# Kern Fan Groundwater Storage Project

Design, Estimating, and Construction Review

June 8 to June 12, 2020

# Total Project Cost

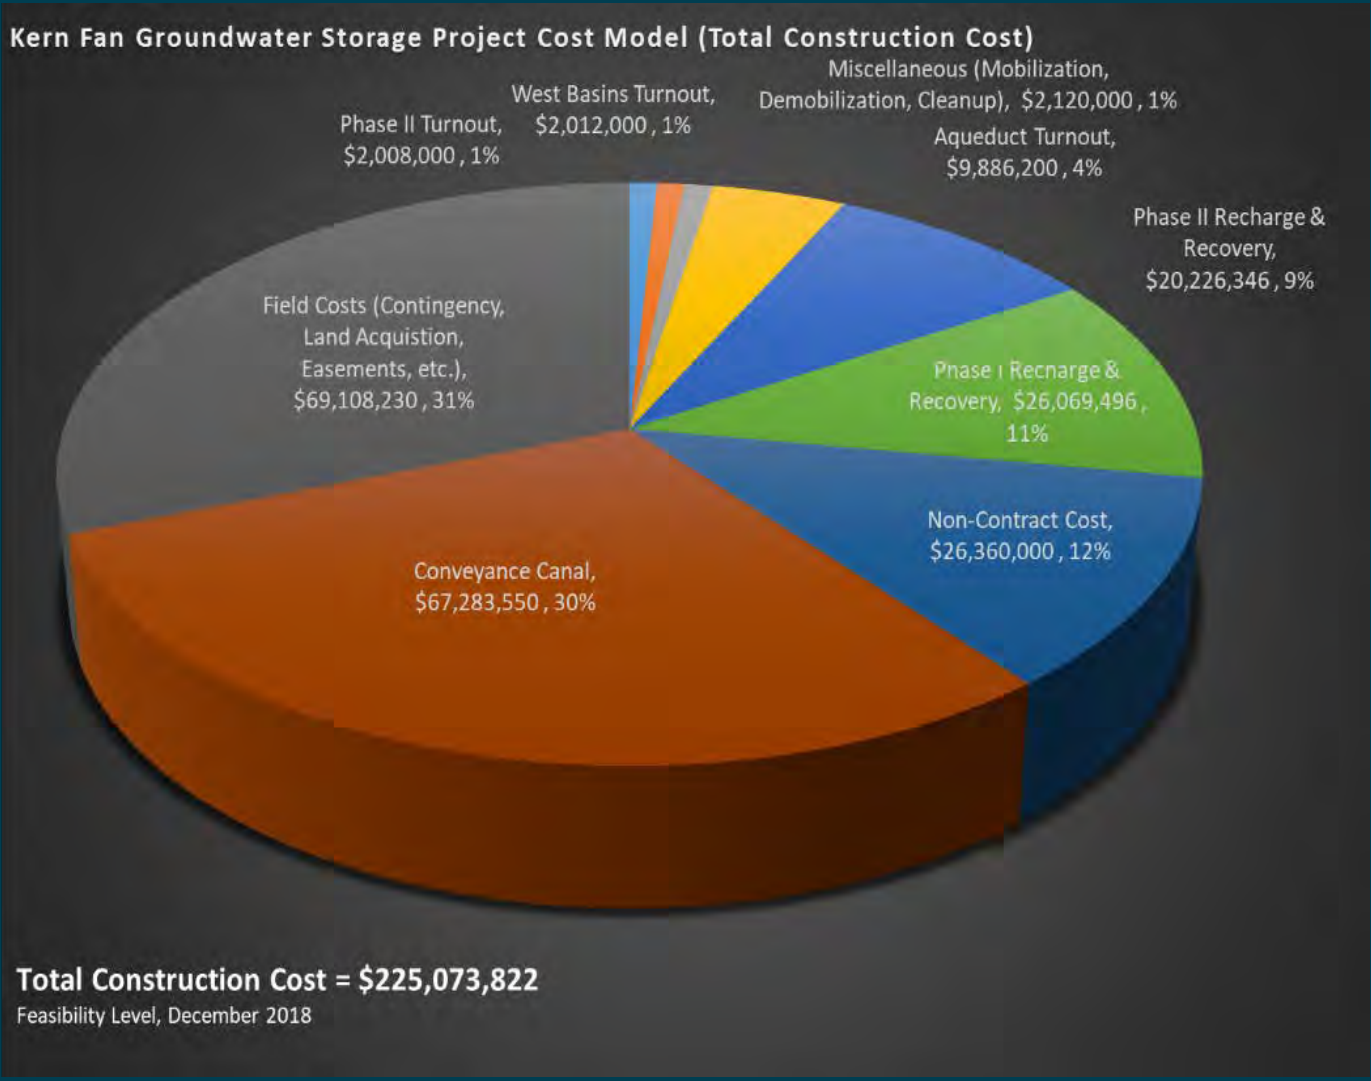
The overall project cost contingency appears to be low for the current level of design.

- The current estimate on the preferred alternative includes a 20% contingency for construction. That is 20% contingency on \$129,605,592 or \$25,921,118.
- The Total Project Cost of \$225,073,822 carries no further contingency. This equates to total project contingency on the total project of 11.5%. Historically at the feasibility level and the current level of design and cost definition the total project contingency should be in the range of 20-50%.

An evaluation of cost risk should be undertaken to determine an adequate level of contingency. This should include risks to project delivery (land acquisition, design, environmental compliance, etc.) in addition to construction contingencies. Risks should be captured for both project dollars and project schedule.

**Arsenic and Depth to  
Groundwater Trends**  
 Figure 3

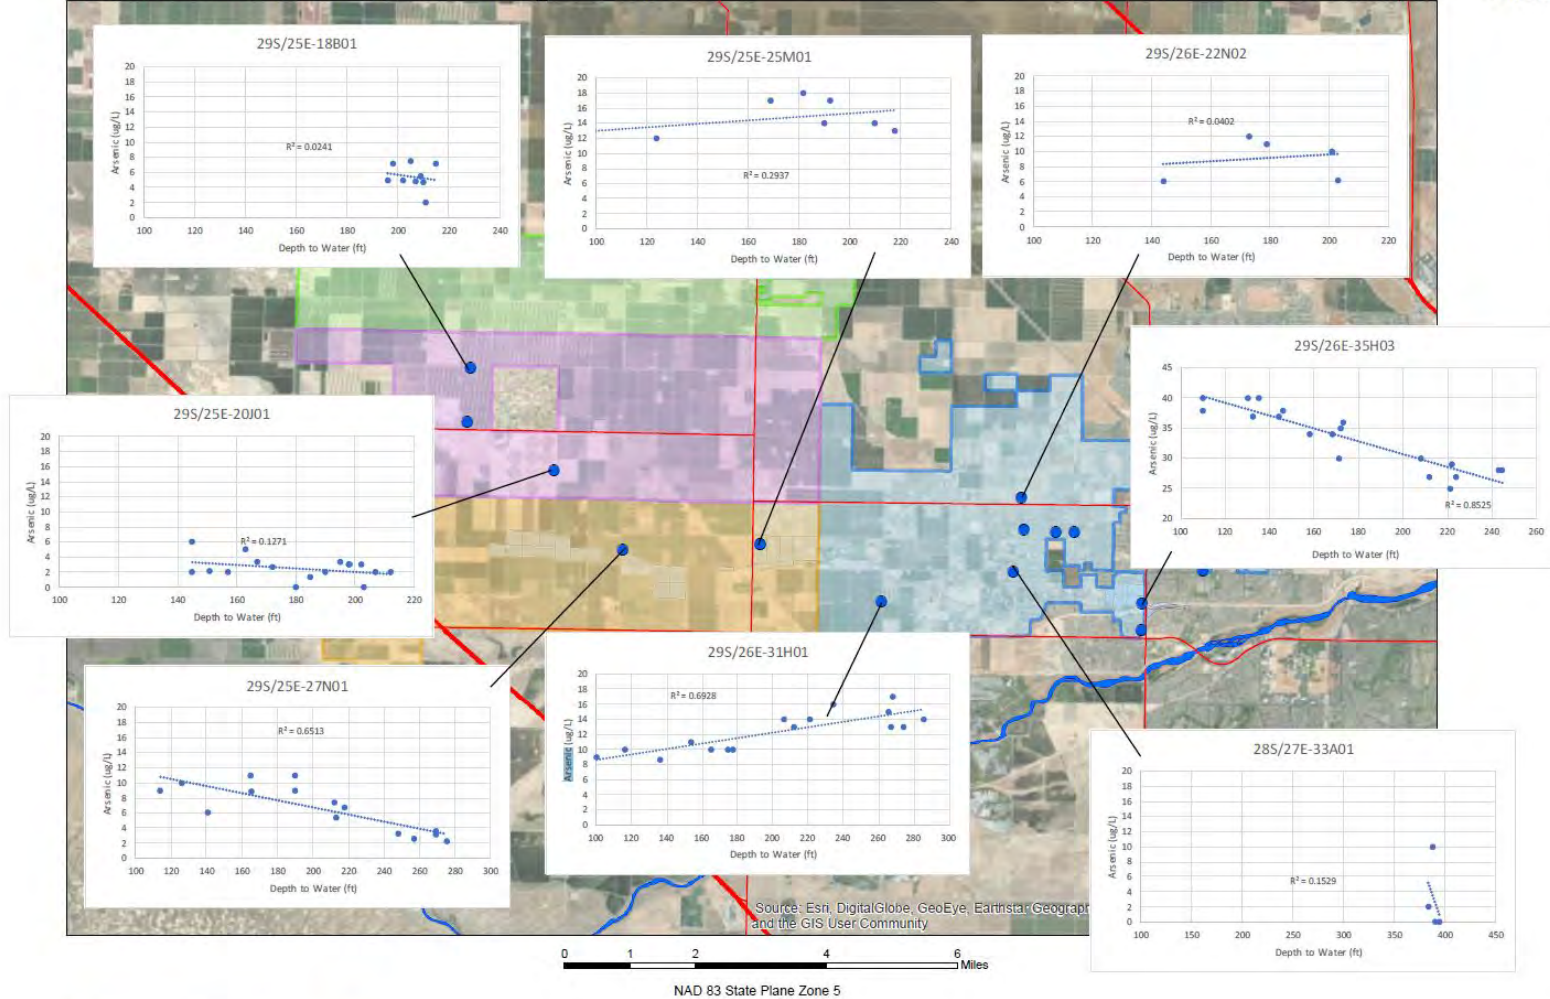
There are no operational plans or contingencies to mitigate high arsenic levels during system startup, in the event that arsenic levels increase over time, or arsenic MCL levels are reduced.

- Arsenic is present in the project area, and local ASR recovery water. An operational plan should be developed to monitor well discharge at startup and adjust as necessary to assure that discharges do not exceed the MCL for arsenic.
- There is a potential for arsenic levels to increase over time as water is infiltrated from the basins.
- Many jurisdictions are considering reducing MCL levels, and there is a possibility that the MCL for arsenic may be lowered during the life of this project.

Develop operational plans with contingencies to handle startup conditions, potential increases in arsenic concentrations, or lower MCLs.
